# South Coast 101 HOV Lanes Project Update

Planning Commission  
September 5, 2013

# Hearing Purpose

# Cabrillo Boulevard Alternative F-Modified

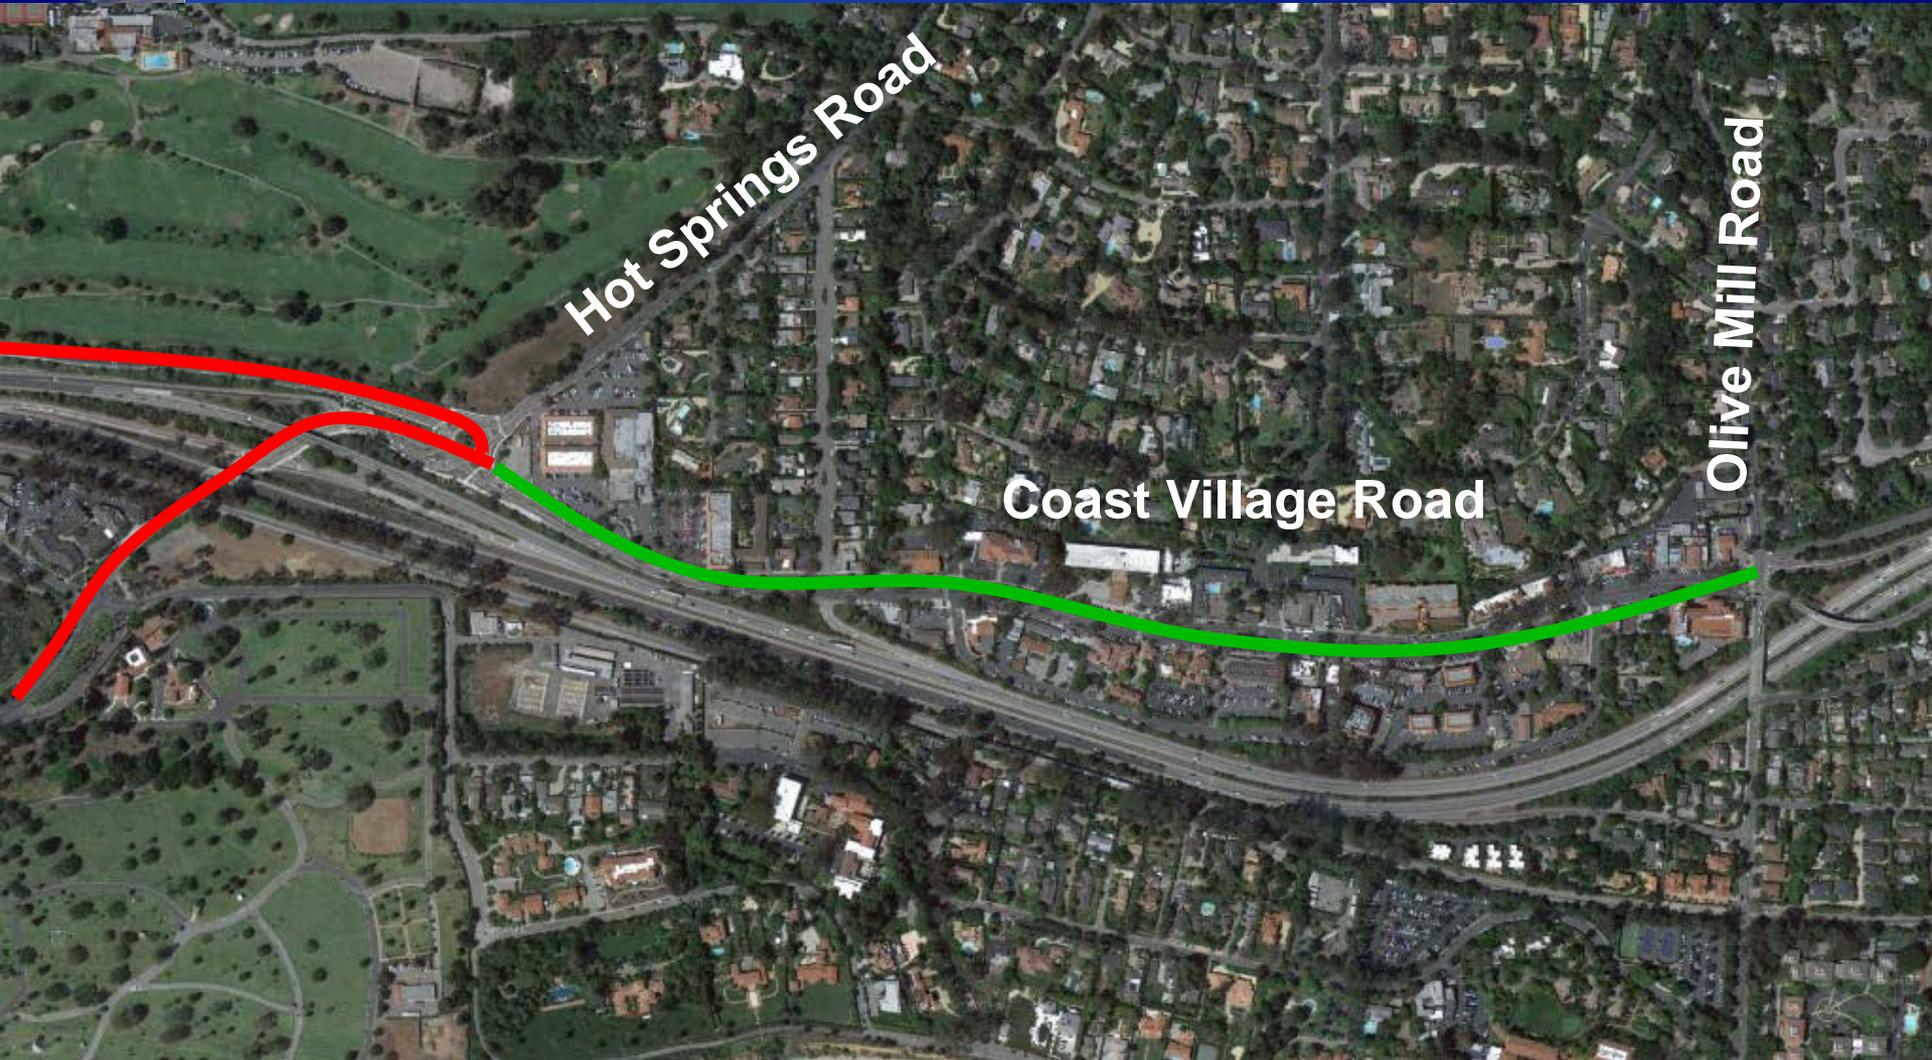
- ◆ No right turn lane provided for SB on-ramp.
- ◆ Short spacing between NB and SB ramps (195')
- ◆ Ped/bike improvements must be accounted for in the design.

- ◆ New interchange design should be a LOS C or better during peak hours.
